AMENDMENT OF SOLICITATION/MODIFICATION OF CONTRACT				1. CONTRACT ID CODE		PAGE OF PAGES 1 2	
2. AMENDMENT/MODIFICATION NO. 0002		3. EFFECTIVE DATE 20-Jan-2023		4. REQUISITION/PURCHASE REQ. NO. W59XQG21385478		5. PROJECT NO.(If applicable)

14. DESCRIPTION OF AMENDMENT/MODIFICATION (Organized by UCF section headings, including solicitation/contract subject matter where feasible.) ELECTRICAL UPGRADE AT EAST TOTTON TRAIL CAMPGROUND, COLE HARBOR, NORTH DAKOTA. POC: Tina Keinig, Email tina.l.keinig@usace.army.mil The purpose of this amendment has a minor error identified in the plan drawings as in the attached. The symbol for new transformer T-1 is shown in the legend as single-phase, instead of the correct three-phase. This affects sheets ES-101, ES-102, ES-103, ES-104.							
Except as provided herein, all terms and conditions of the document referenced in Item 9A or 10A, as heretofore changed, remains unchanged and in full force and effect.							
15A. NAME AND TITLE OF SIGNER (Type or print)				16A. NAME AND TITLE OF CONTRACTING OFFICER (Type or print) JOHN D HICKMAN / PCO TEL: 402-995-2613 EMAIL: JOHN.D.HICKMAN@USACE.ARMY.MIL

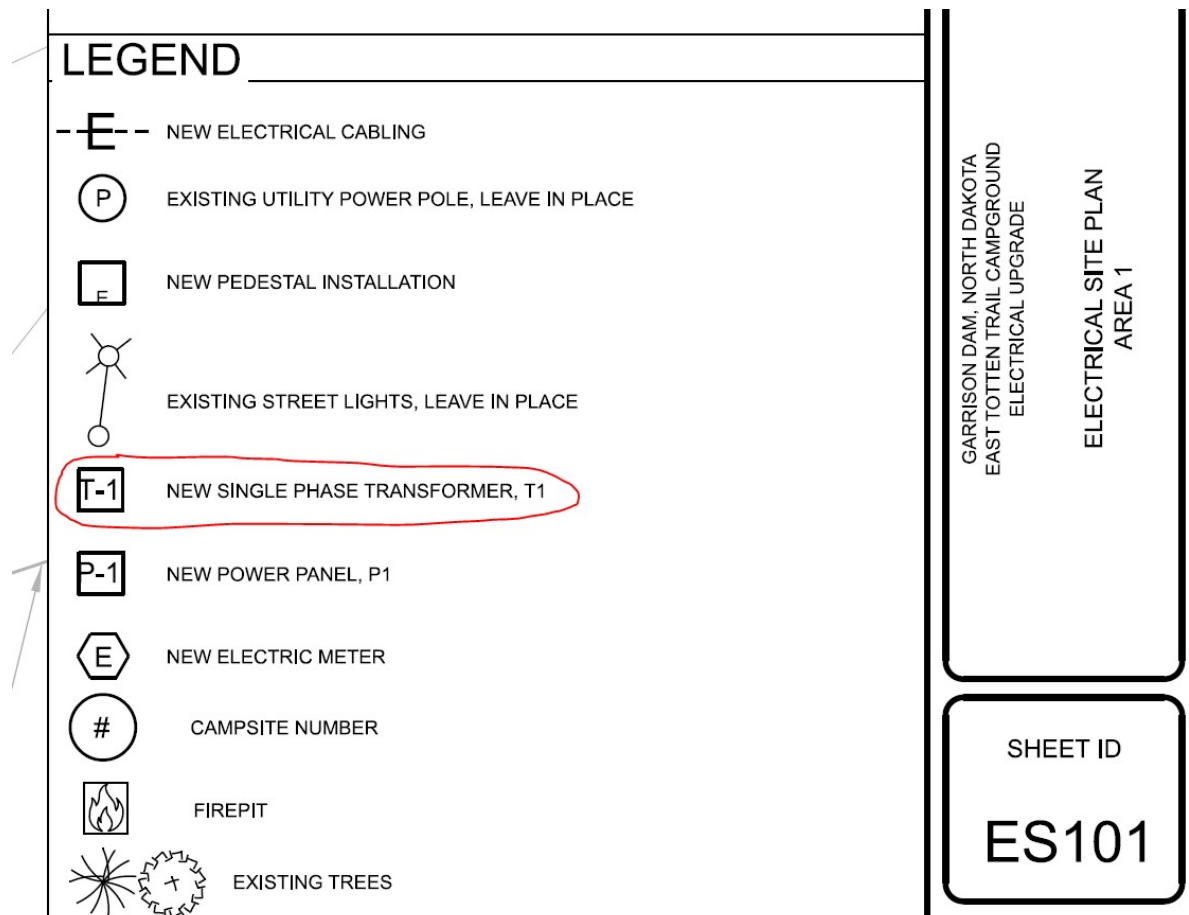
Minor error identified in the plan drawings as shown below. The symbol for new transformer T-1 is shown in the legend as single-phase, instead of the correct three-phase. This affects sheets ES-101, ES-102, ES-103, ES-104.
